UNITED STATES PATENT AND TRADEMARK OFFICE

APPLICATION NO.	FILING DATE	FIRST NAMED INVENTOR	ATTORNEY DOCKET NO.	CONFIRMATION NO.
10/755,427	01/12/2004	Lee Bolduc	203-2626 DIV CON VIII (24)	9695
7590 04/10/2009				
Mark Farber, Esq. U.S. Surgical, A Division of Tyco Healthcare Group, LP 150 Glover Avenue Norwalk, CT 06856				
EXAMINER YABUT, DIANE D				
ART UNIT		PAPER NUMBER		
3734				
MAIL DATE		DELIVERY MODE		
04/10/2009		PAPER

Office Action Summary

DETAILED ACTION

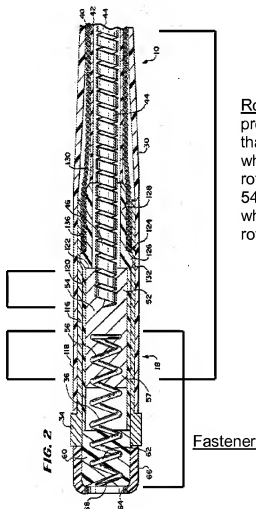
Claims 1, 4-6 and 19: Miller discloses an applicator comprising a distal portion having an elongate outer tube **30**, a connecting end and a terminal end, a proximal portion having a handle and an actuator **22**, the proximal portion being attached to the connecting end of the distal portion, and a rotator **44** cooperating with the actuator, the rotator including a longitudinal groove extending along at least a portion thereof (within the distal end **54** of rotator), the groove configured to receive a portion of a fastener **36**, wherein the rotator resides within and extends substantially the length of the outer tube such that actuation of the actuator rotates and translates the fastener relative to the outer tube while the rotator remains longitudinally or axially stationary with respect to the outer tube (Figures 1-3; col. 5, line 57 to col. 6, line 22). The applicator has a thread form **62** contained in an interior of the terminal end adapted to engage a plurality of fasteners and being an interlock spring fixedly retained in the interior of the terminal

end, wherein "spring" is taken to mean an "actuating force." This may also be considered as a nose piece **60** that has structures projecting perpendicularly toward a longitudinal axis of the outer tube and adapted to engage a plurality of fasteners. The proximal and distal portions

Longitudinal grooves are within distal end 54 of rotator which engage with the proximal end 44 of rotator and proximal end of fastener 62

Rotator has a proximal end 44 that is rotated, which in turn rotates a distal end 54 of the rotator, which ultimately rotates fastener 62

8. Applicant's arguments filed 02/05/2009 have been fully considered but they are not persuasive.
9. The applicant generally argues that Miller fails to disclose the rotator having a longitudinal groove extending along at least a portion thereof. The examiner disagrees. The examiner mentioned that the longitudinal groove is within a distal end **54** of the rotator, which rotates along with a proximal end **44** of the rotator, and holds the proximal end of a helical fastener **62**, as clarified in the annotated figure 2 above. In order to be mounted onto the distal end **54**, there must be a groove that accepts the fastener **62**, which is suggested in figure 2.
